A G E N D A
CANBY PLANNING COMMISSION
REGULAR MEETING
City Council Chambers
Monday, April 11, 1994
7:30 p.m.

- STAFF REPORT -

SUB 94-01
(Pittuzi Estates)

PIZZUTI ESTATES

Subdivision Application

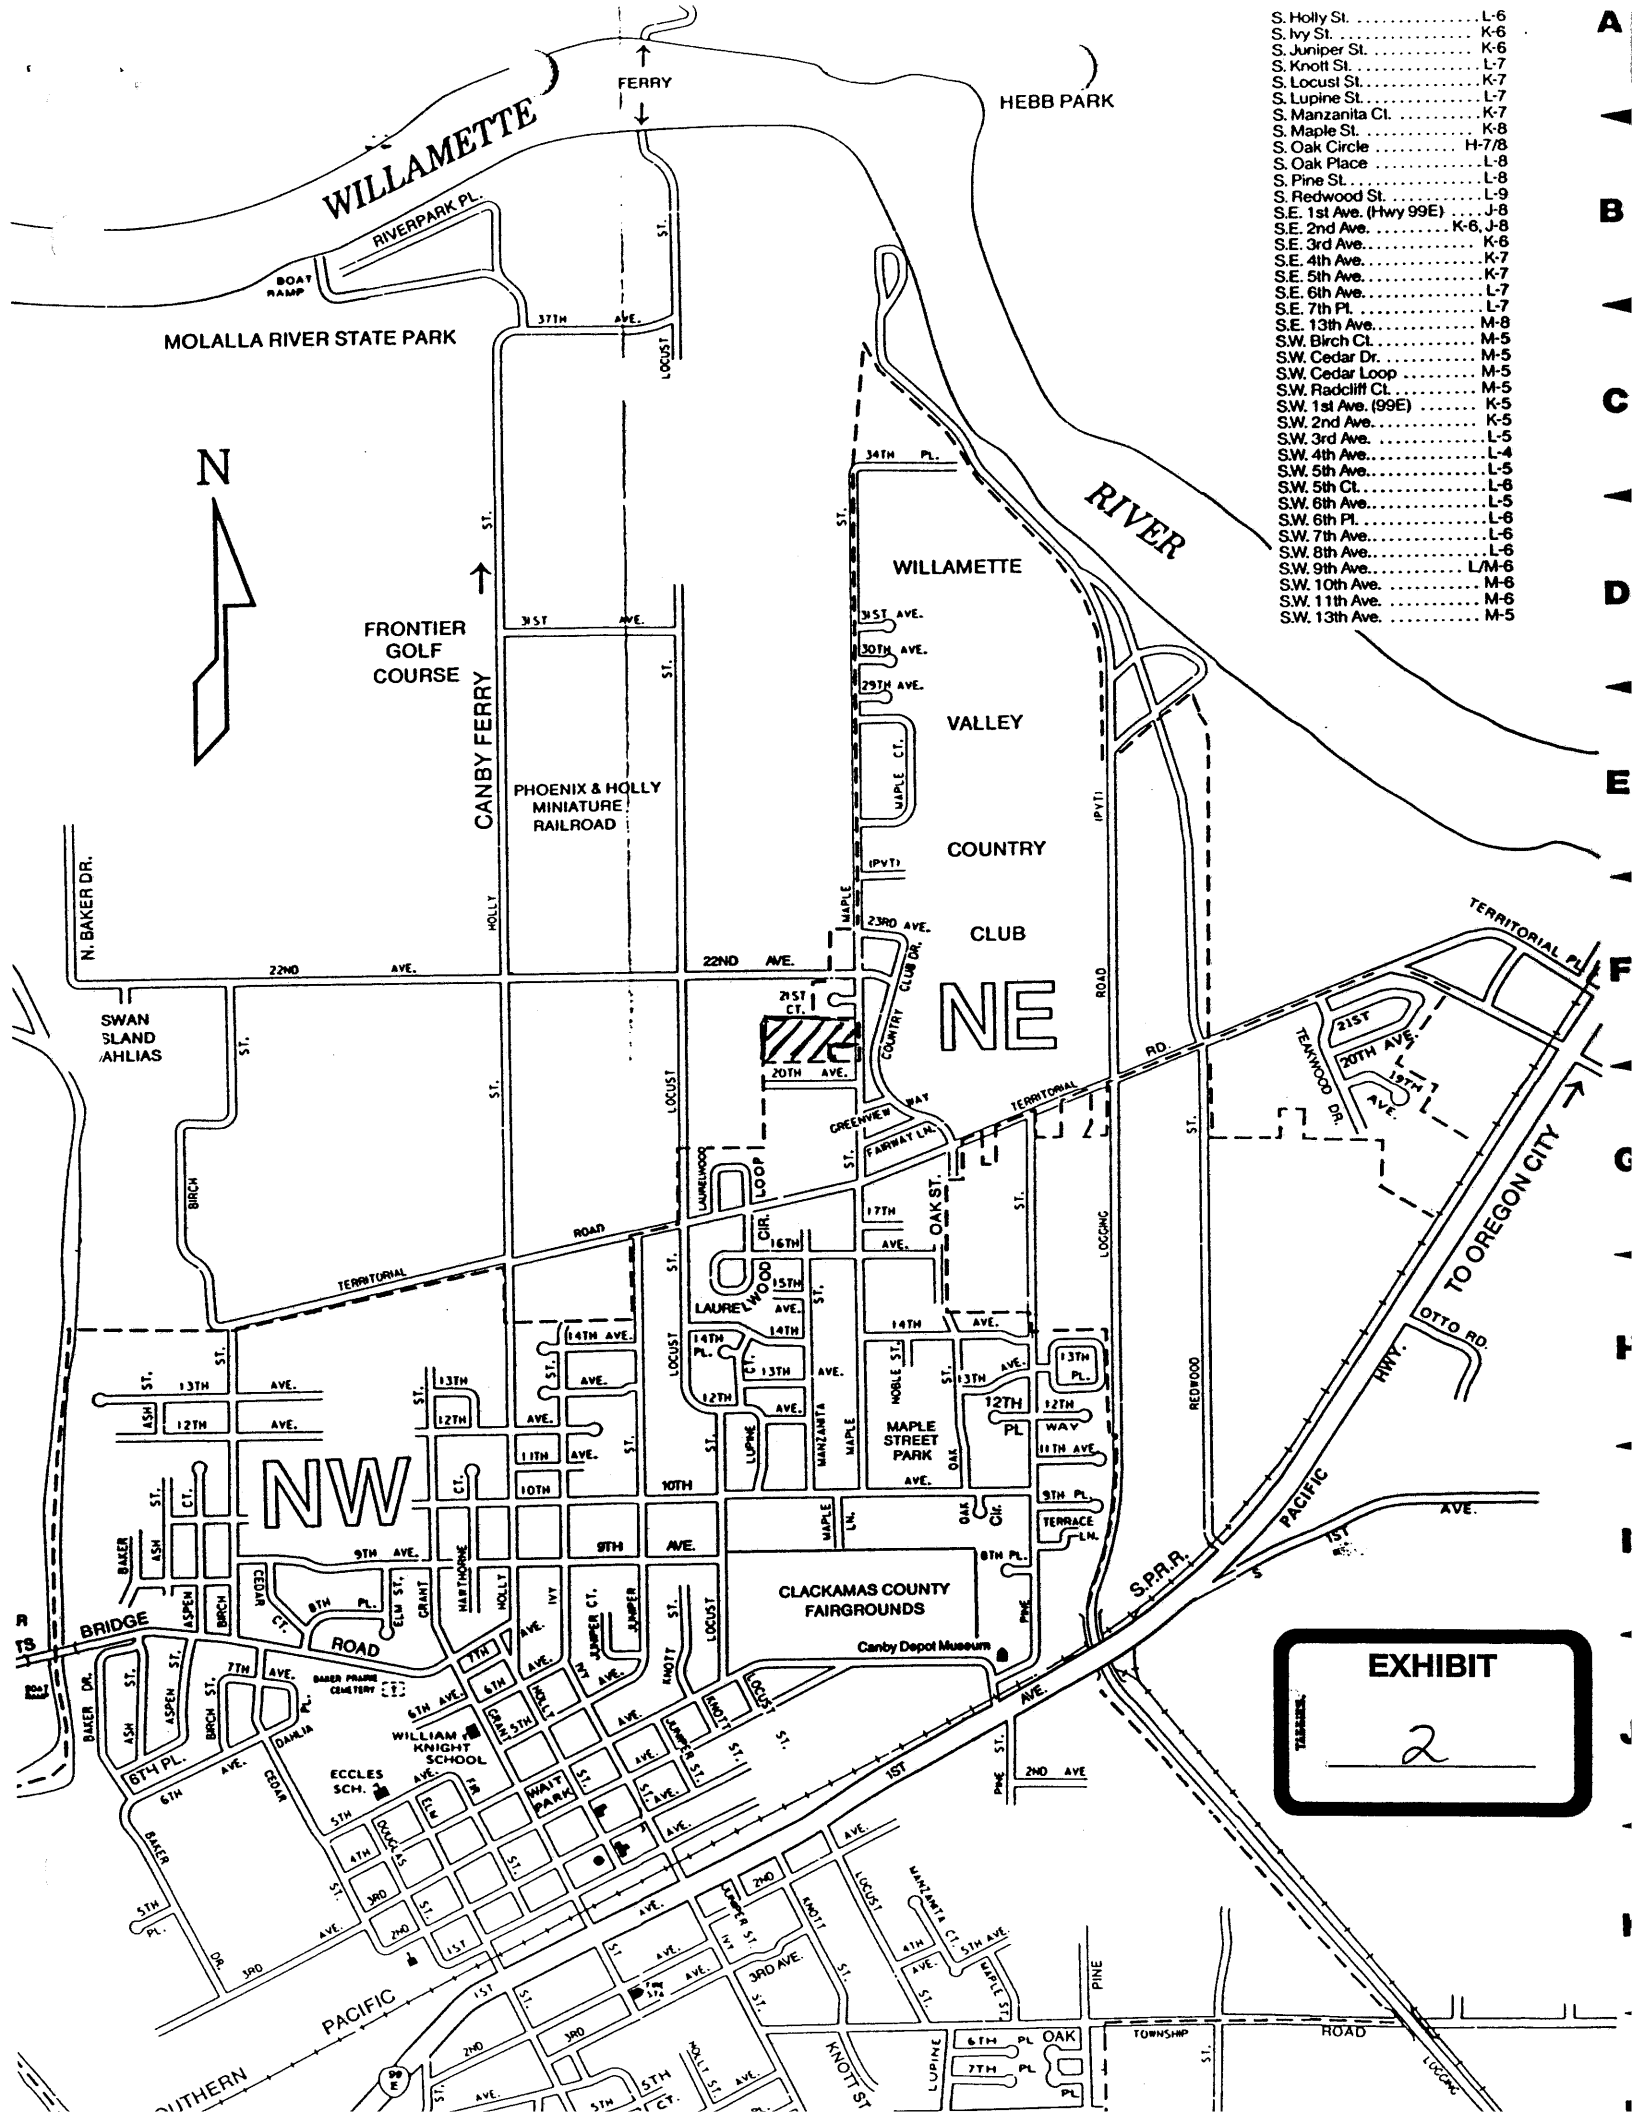
The applicant is proposing an interior forty (40) foot road right-of-way, with a 'bulb' along the southern part of the proposed road, toward the western end of the development. The proposed street, unnamed on the application plat, will be named N.E. 21st Avenue. The road is proposed to be continued when the property to the west is annexed and developed (it is within the Urban Growth Boundary), and therefore the name extension is in accordance with the street naming ordinance. The 'bulb' will provide emergency vehicles a place to turn around, until the street is continued. The 'bulb' will remain after the street is continued. A similar street layout is existent along S. Elm Court, and functions sufficiently. A one (1) foot reserve strip, controlled by the City, is needed to control access to N.E. 21st Avenue from the west.

The location of the intersection of N.E. 21st Avenue and N. Maple Street will need to be located ten (10) feet further to the north. The right-of-way for N.E. 21st Avenue will need to be widened by ten (10) feet for the portion that abuts tax lot 601. The moving of the street and the widening of the right-of-way will permit sidewalk and street placement along that portion of the southern side of N.E. 21st Avenue. Given the dimensions shown for the house on tax lot 601, it would appear that further development of that lot is unlikely, and thus sidewalk and street tree improvements as a part of development of that lot are also unlikely. The developer of the subject parcel can apply for advanced financing of improvements that will benefit tax lot 601, thus allowing for reimbursement for the improvements made should tax lot 601 be further developed.

There was no proposed street name on the application plat. In accordance with the street naming ordinance, N.E. 21st Avenue will be the designated name. The right-of-way for N.E. 21st Avenue will be reduced to forty (40) feet. A one (1) foot reserve strip will be required for the west end of N.E. 21st Avenue.

Six foot utility easements are proposed to be located along all interior lot lines. The non-street exterior property line of the portion of lot #8 along the north, abutting the Brandy Estates Subdivision Lots (N.E. 21st Place) will need only a six foot permanent utility easement, as there is already an easement on those adjoining lots. Twelve foot utility easements will be needed for all other exterior lot lines. Twelve foot utility easements are proposed along all street lot lines. A twelve foot tree-planting easement is also proposed along all street lot lines, this will allow the City to plant street trees at the desired location (12 feet from the curb), if the developer pays the cost of \$75 per tree.

4. The name of the public right-of-way shall be N.E. 21st Avenue.
5. A one foot plug shall be provided at the west end of N.E. 21st Avenue to prevent access to the west until annexed and/or platted.

6. The right-of-way width for N.E. 21st Avenue shall be fifty (50) feet for that portion of the right-of-way that abuts tax lot 601 (tax map 3-1E-28DB). The remainder of the right-of-way shall be tapered to a forty (40) foot right-of-way as proposed.

13. The centerline of N.E. 21st Avenue shall be located twenty (20) feet south of the northern right-of-way limit.
14. The sidewalks shall be located against the curb, and shall be five-feet wide. Where mailboxes, newspaper boxes or other obstructions (such as fire hydrants) are located at the curb, the sidewalk shall be set away from the curb such that the sidewalk remains unobstructed for a full five-foot width.
